# STATE OF OHIO DEPARTMENT OF TRANSPORTATION

## DEF-24-11.35

CONSTRUCT A NEW 0.42 MILE 2-LANE OVERPASS AT THE US24/CR 185 AT-GRADE INTERSECTION & REMOVE CURRENT INTERSECTION. THE PROJECT CONSISTS OF RAISING CR 185 OVER US24 ON THE EXISTING ALIGNMENT, CONSTRUCTING A NEW 2-SPAN BRIDGE & REMOVING INTERSECTION PAVEMENT ON US 24 & RESTORING US 24 TO A 4-LANE DIVIDED FACILITY.

ADDENDUM	NUMBER	DATE	DESCRIPTION
	1	02/14/2025	UPDATED DATE

PLAN US 24  
 STA. 842+60 TO STA. 848+20

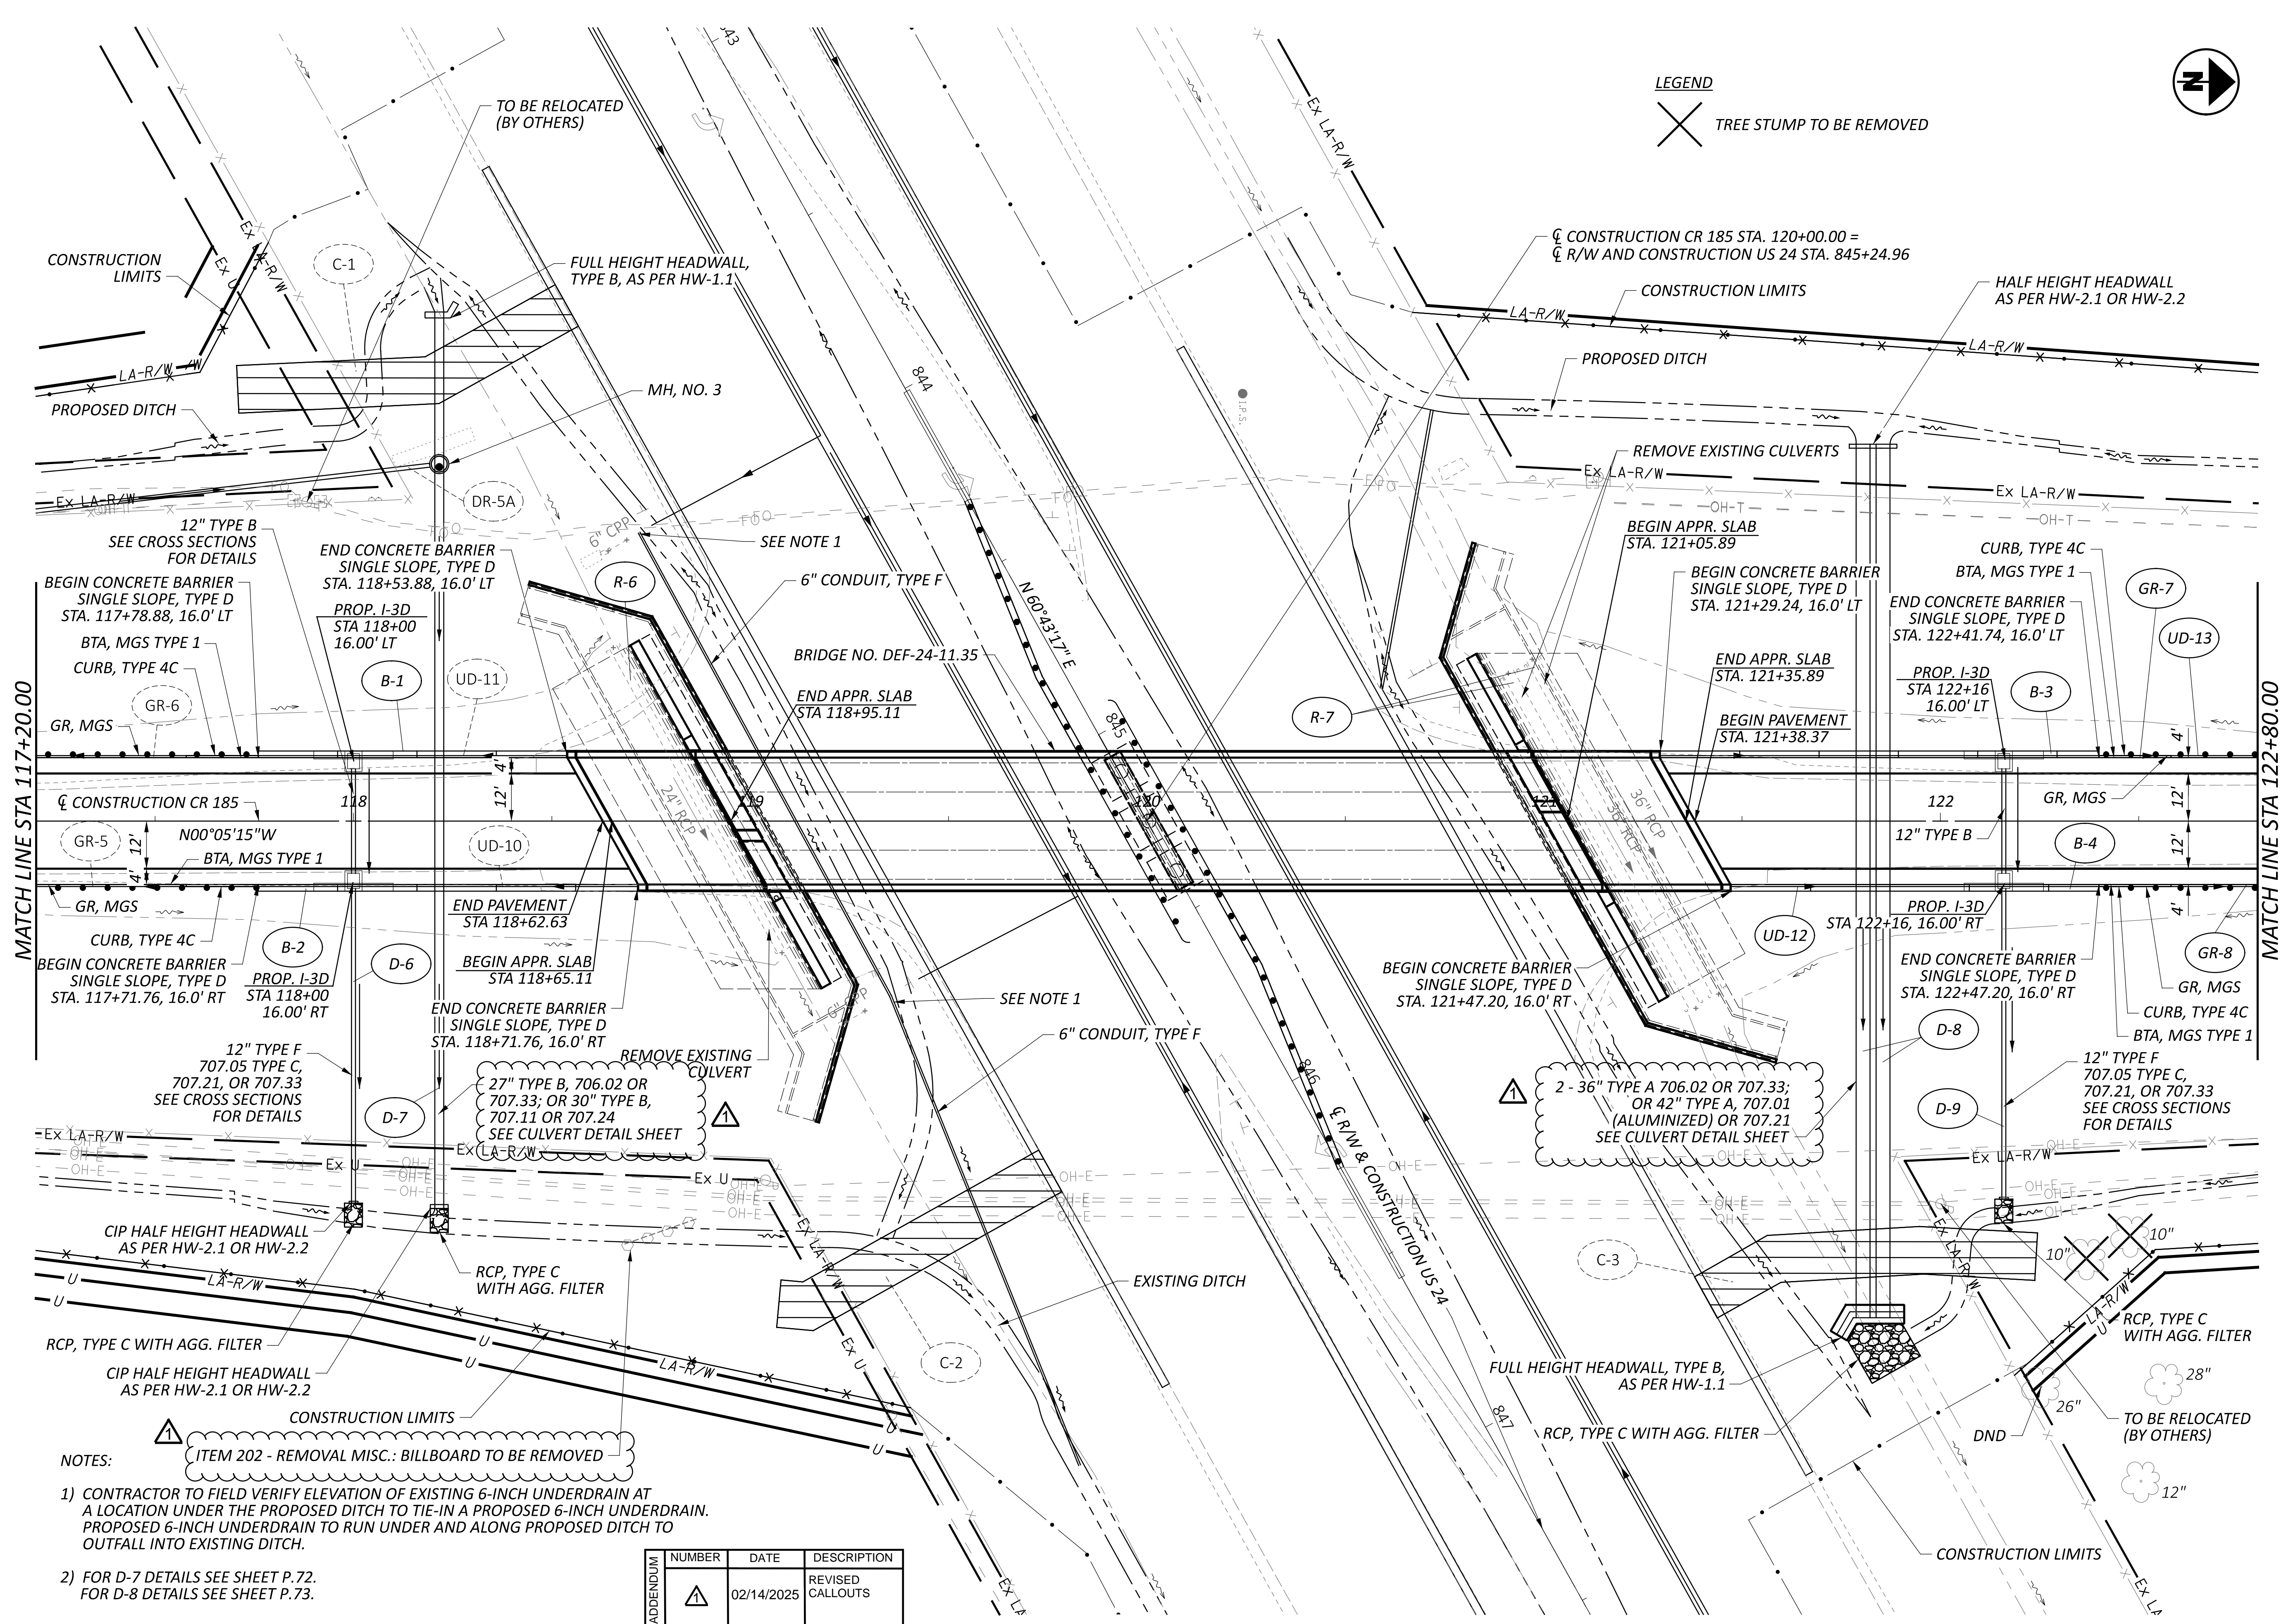
ADDENDUM	NUMBER	DATE	DESCRIPTION
▲		02/14/2025	REVISED CALLOUTS

PAVEMENT TO BE REMOVED, AS PER PLAN  
 ITEM 204 - SPECIAL - GEOCELL, SUBGRADE, 6", GEOWEB

PLAN CR 185  
 STA. 117+20 TO STA. 122+80

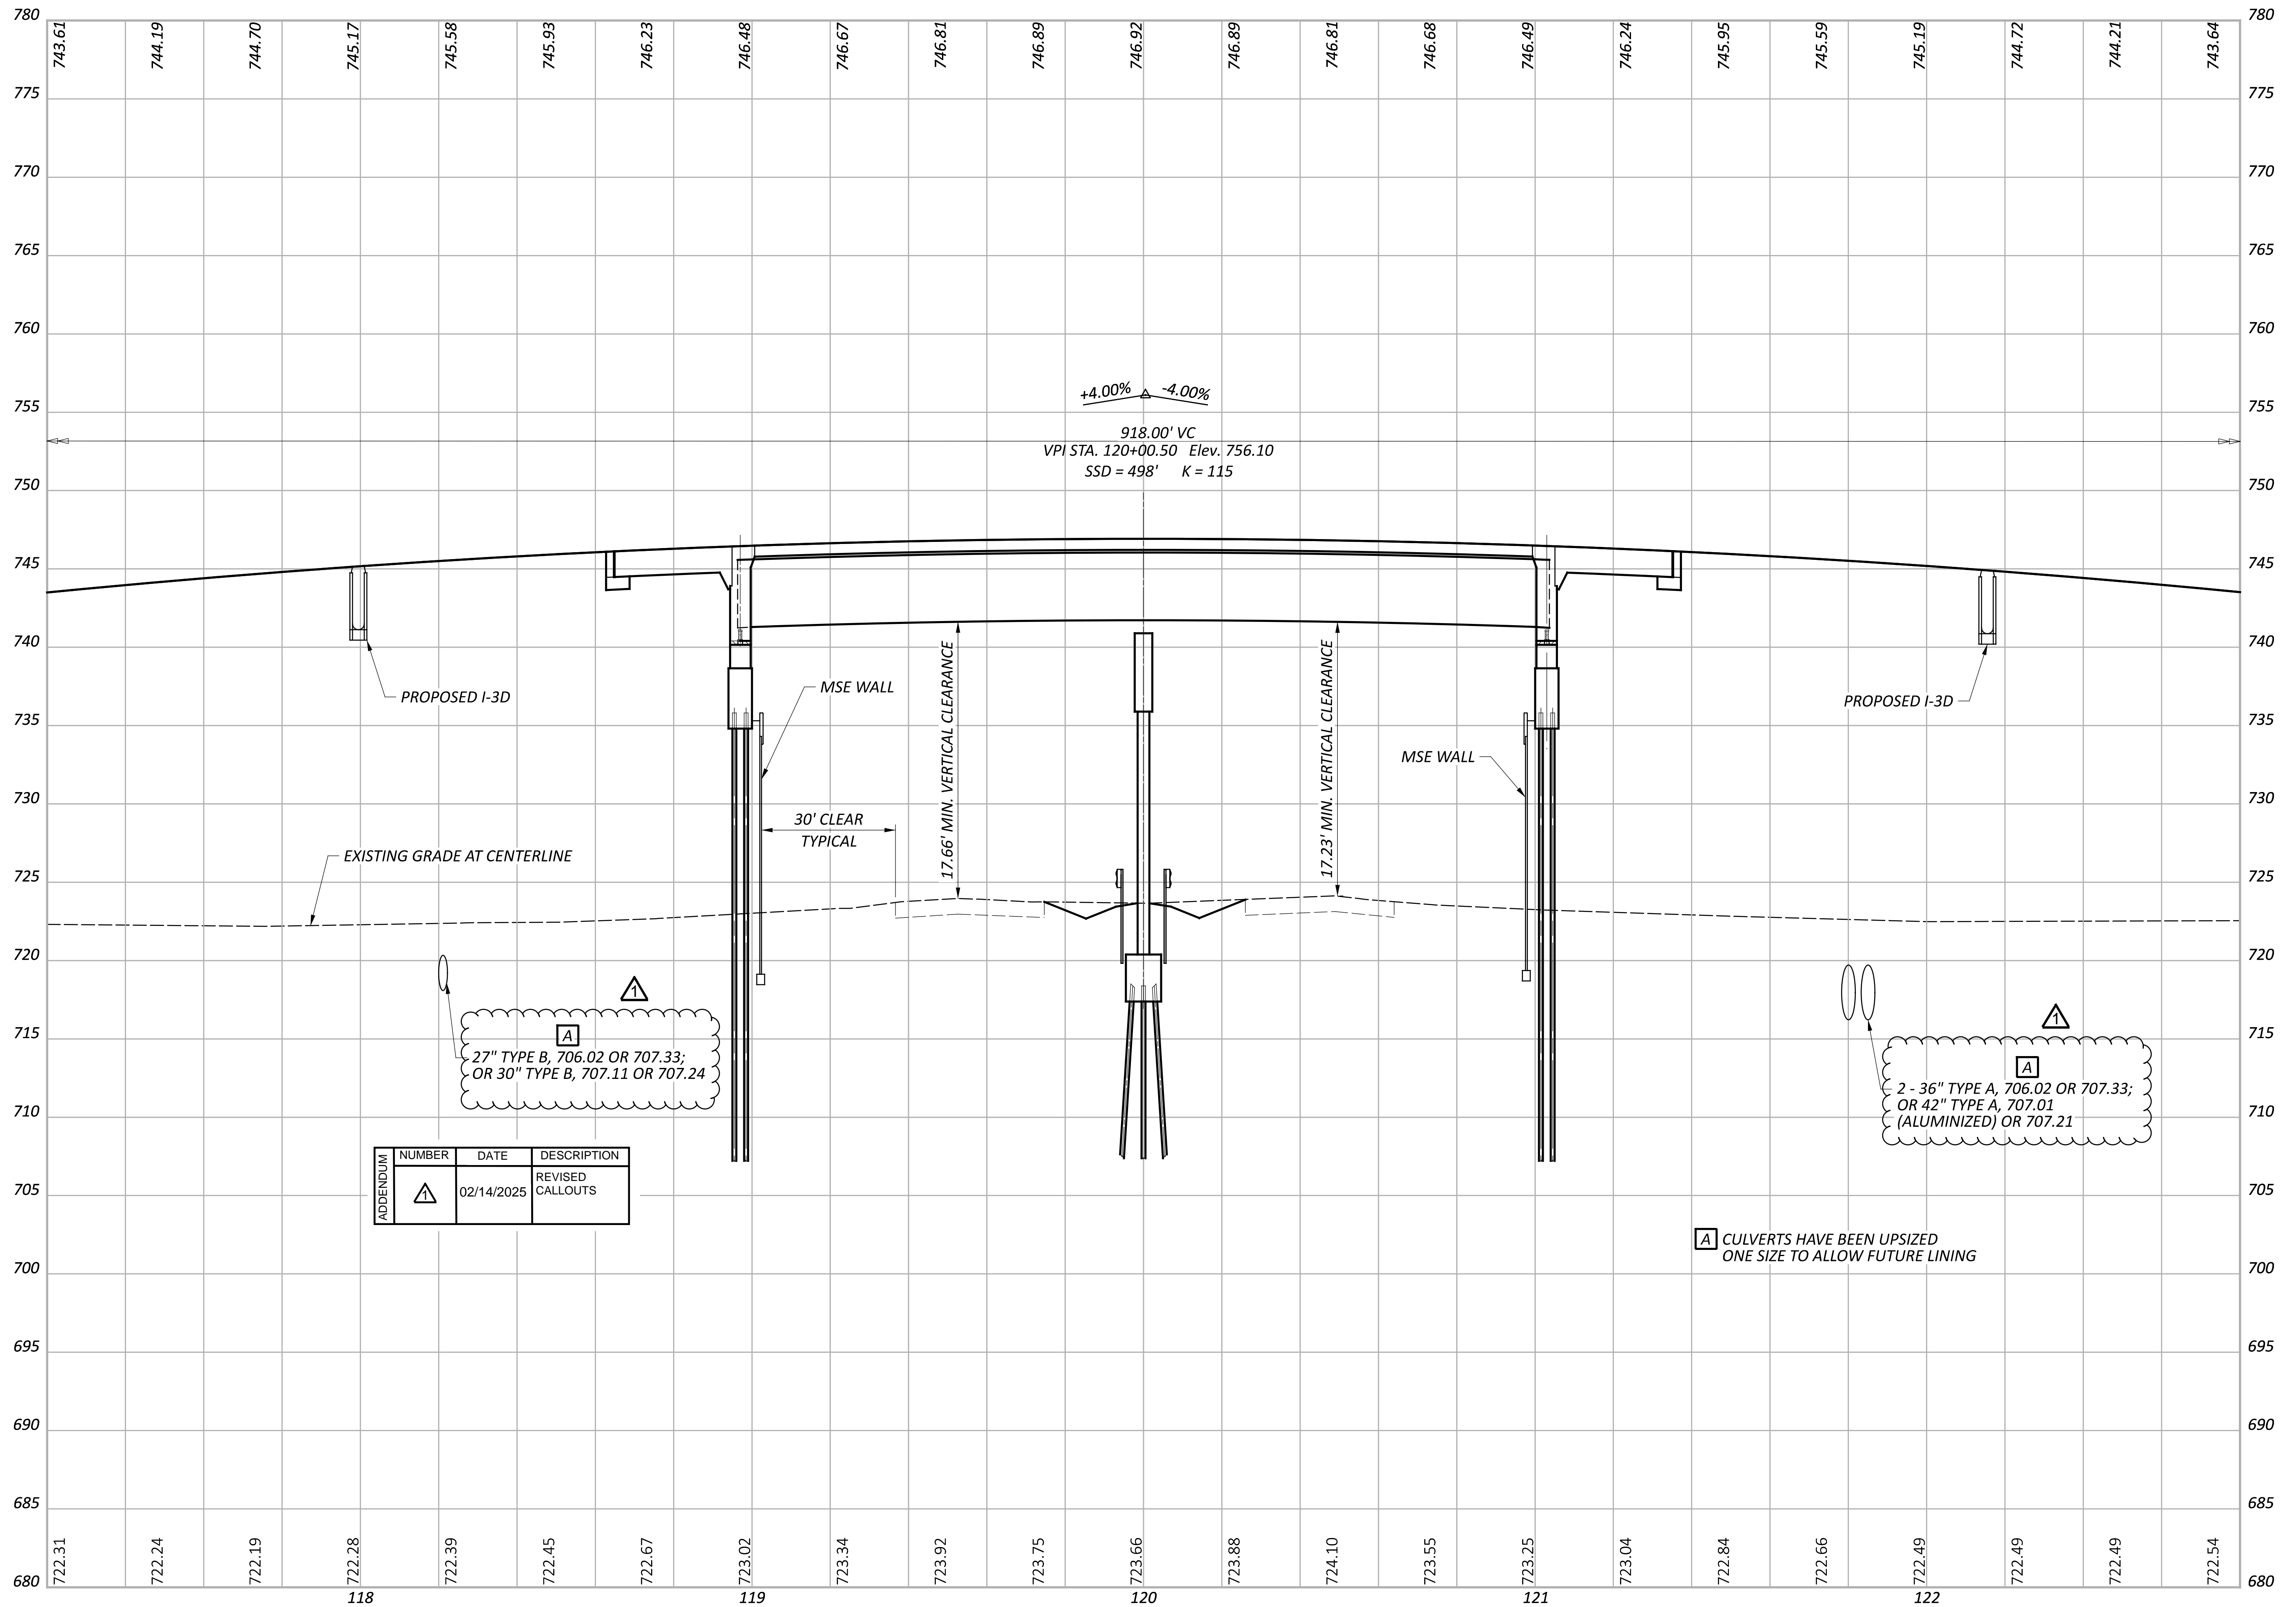
ADDENDUM	NUMBER	DATE	DESCRIPTION
▲		02/14/2025	REVISED CALLOUTS

**A** CULVERTS HAVE BEEN UPSIZED ONE SIZE TO ALLOW FUTURE LINING
